NINE MILE POINT
NUCLEAR STATION

SUBJECT: Nine Mile Point Nuclear Station
Unit No. 2; Docket No. 50-410

Response to Request for Additional Information Regarding Nine Mile Point Nuclear Station, Unit No. 2 – Re: The License Amendment Request for Extended Power Uprate Operation (TAC No. ME1476) – Steam Dryer and Probabilistic Risk Assessment

RESPONSE TO REQUEST FOR ADDITIONAL INFORMATION REGARDING LICENSE AMENDMENT REQUEST FOR EXTENDED POWER UPRATE OPERATION (NON-PROPRIETARY)

Figure 20-1. Eigenmode at 263.6 Hz, corresponding to the fundamental mode of the closure plate generated with Model 2. The top view shows participation of the inner hood.

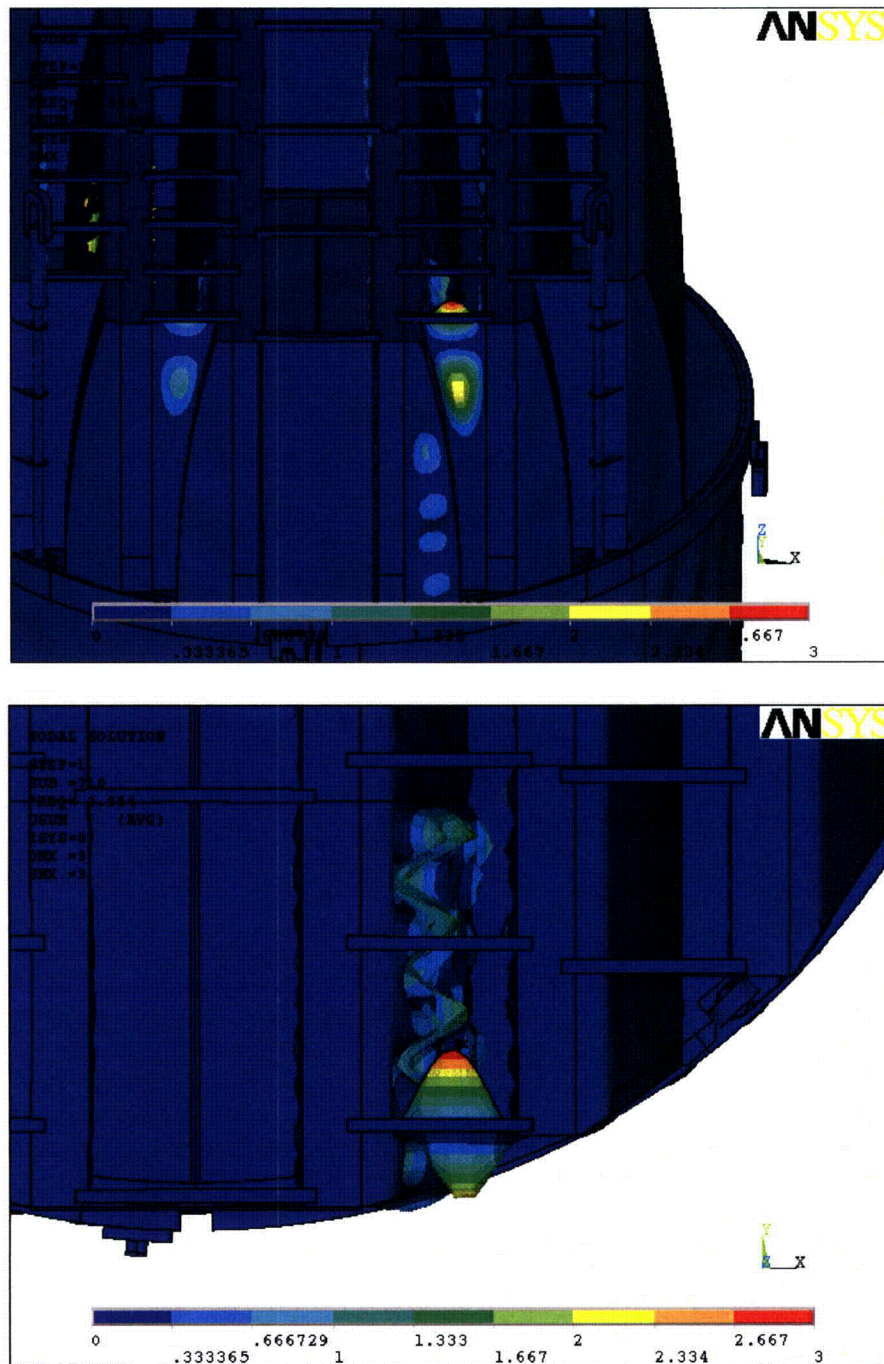
Appendix A of the CDI report 09-26P, "Stress Assessment of Nine Mile Point Unit 2 Steam Dryer at CLTP and EPU Conditions", discusses submodeling and the closure plate modification, which includes the addition of stiffening ribs on the plate, so that the alternate stress ratio will be greater than 2.0. The staff requests details on how the modified closure plate is incorporated in the finite element model of the steam dryer. The licensee has incorporated the increased fundamental frequency (256 Hz) of the modified plate by increasing the thickness of the original unmodified plate. The fundamental mode shape of the modified closure plate would be different than that of the unmodified plate, and is not accounted for in the finite element model that is used to calculate the stresses in the steam dryer. As discussed in Appendix A (p. 95), the shape of the fundamental mode would determine the locations of the significant stresses. Therefore, the licensee is requested to include both the fundamental frequency and mode shape of the modified closure plate in the finite element model, perform the stress analysis using this model, and then provide the resulting stresses.

The procedure for incorporating the thickened closure plate solution is as follows: First, the closure plate is considered by itself in order to *design* the necessary reinforcements. For this purpose, the closure plate support and forcing conditions do not need to be exactly the same as in the full model since *evaluation* of the design is subsequently carried out on the complete steam dryer.

Once the design of the closure plate is finalized, a finite element model of the complete steam dryer with the thicker closure plates is constructed. This is accomplished by using the ANSYS model (referred to as Model 1) developed for the dryer with the original unmodified closure plates, selecting the closure plates and assigning new thicknesses to these components. The revised model of the complete steam dryer with the thicker closure plates incorporated is referred to as Model 2. [[

For completeness, the fundamental frequency and mode shape of the thickened closure plate, when connected to the complete NMP2 steam dryer, are calculated using Model 2 (entire steam dryer with the fully integrated thicker closure plate). The fundamental frequency is 263.6 Hz, which is close to the 256 Hz frequency of the isolated closure plate. The accompanying mode shape is given in Figure 20-1 and is clearly seen to involve participation of connected members such as part of the hood. As already indicated, this coupled mode is included in the harmonic analysis used to generate the results in Attachment 15 of the NMPNS letter to NRC dated December 23, 2009.

Figure 21-1. Coarse grid (top) and fine grid (bottom) in solid sub-model.

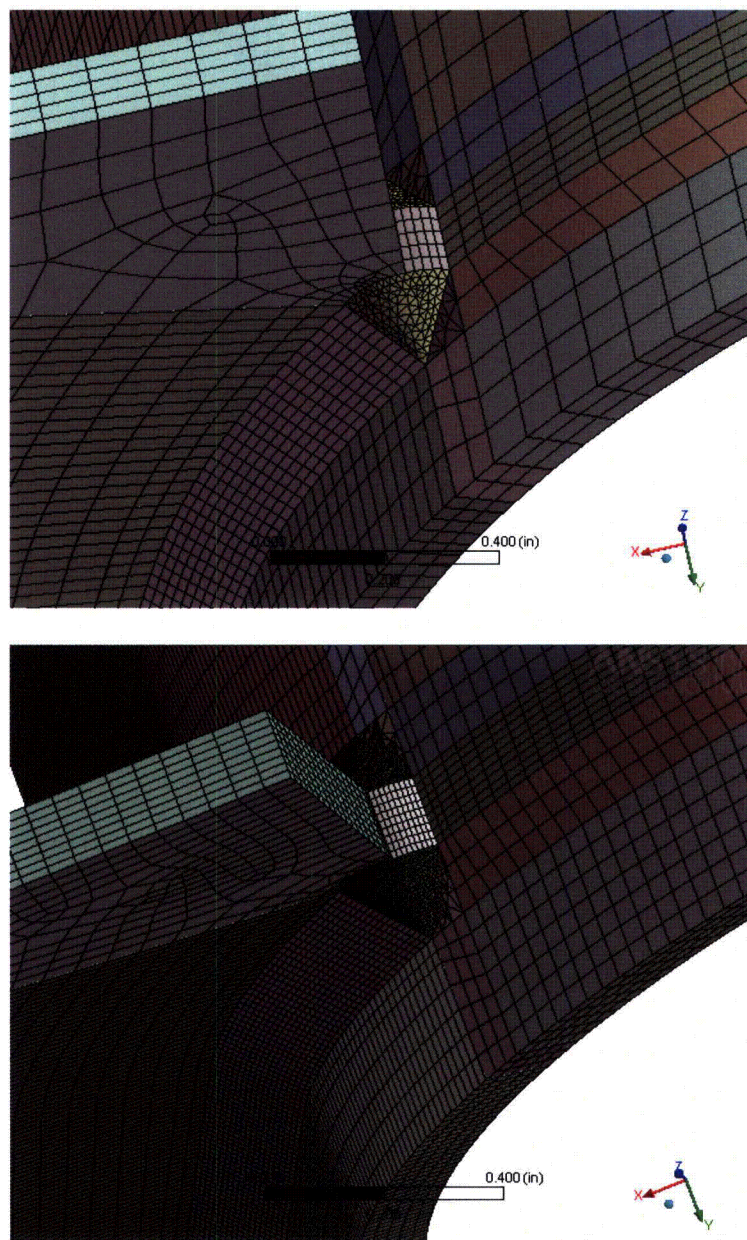
For submodeling analysis of the modified closure plate, the applicant cuts the global model by an intersection box (typically a 6" cube) and obtains the resulting intersection lines as discussed in Appendix A of the CDI Report 09-26P. The licensee is requested to confirm whether the intersection lines are located at an adequate distance away from the weld, so that the mesh refinement at the weld produces local changes to stress and strain, while stresses and displacement on the intersection lines remain unchanged.

The effects of mesh refinement in the sub-model are examined by means of the following example for one of the reinforced closure plate/hood attachment welds (node 95172) described in Appendix A of Attachment 15 of the NMPNS letter to NRC dated December 23, 2009. Since the baseline solid element mesh used in the original evaluation is already extremely fine (reported sub-model are usually solved in the finest grid possible with the available computational memory), the mesh is coarsened to approximately twice the grid spacing and the stress results compared. The total number of nodes in the coarse grid is 166,931 and total number of nodes in the finer grid is 828,504. Figure 21-1 shows the grids in the vicinity of the high stress location.

Identical loadings are applied to the sub-model. The expectation is that while stresses at re-entrant corners will change, the linearized stresses used to generate the stress reduction factors will be converged. In Table 21-1 linearized stress results for the fine grid are reproduced from Table 13 in Appendix A of Attachment 15 of the NMPNS letter to NRC dated December 23, 2009, and compared to the corresponding values for the coarse grid. The stress distributions along the paths C-C1 (the path with the highest linearized stress) are compared in Figure 21-2 revealing how the stress singularities change with grid refinement, but linearized stresses are converged. For the limiting path C-C1 the linearized stresses obtained with the coarse and fine mesh models differ by less than 0.5%. For all remaining lower stress paths the stress differences are less than 8%.
